SUNDRY NOTICES AND REPORTS ON WELLS

1. OIL WELL <input type="checkbox"/> GAS WELL <input checked="" type="checkbox"/> OTHER <input type="checkbox"/>	7. UNIT AGREEMENT NAME Carson Unit
2. NAME OF OPERATOR Hixon Development Company	8. FARM OR LEASE NAME
3. ADDRESS OF OPERATOR P.O. Box 2810, Farmington, N.M. 87499	9. WELL NO. 342-15
4. LOCATION OF WELL (Report location clearly and in accordance with any State requirements.* See also space 17 below.) At surface 2460' FNL, 885' FEL, Sec. 15, T25N, R12W, NMPM	10. FIELD AND POOL, OR WILDCAT Basin Fruitland Coal
14. PERMIT NO.	11. SEC., T., R., M., OR BLK. AND SURVEY OR AREA Sec. 15, T25N, R12W
15. ELEVATIONS (Show whether OF, BT, GR, etc.) 6212' GLE	12. COUNTY OR PARISH San Juan
	13. STATE N.M.

Please accept this sundry as an amendment to the Application for Permit to Drill for the above referenced well.

Hixon Development Company Drilling Rig Location Plat

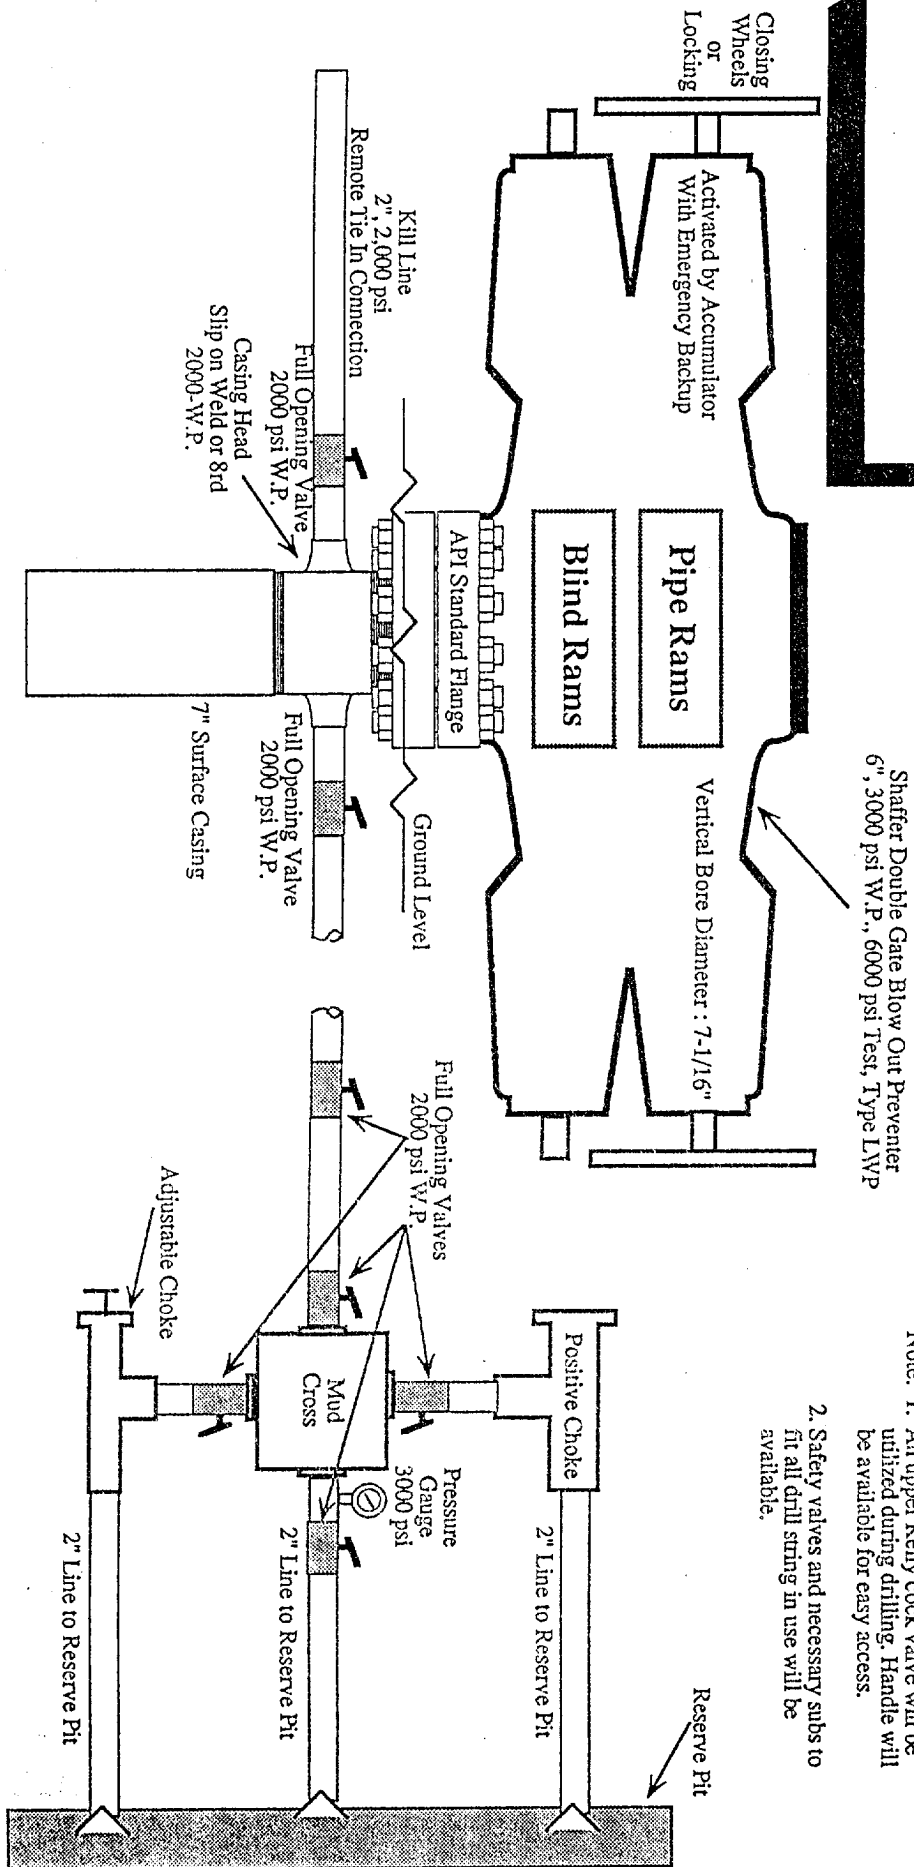
Attached are an amended Pressure Control Equipment Schematic and Drilling Rig Location Plat.
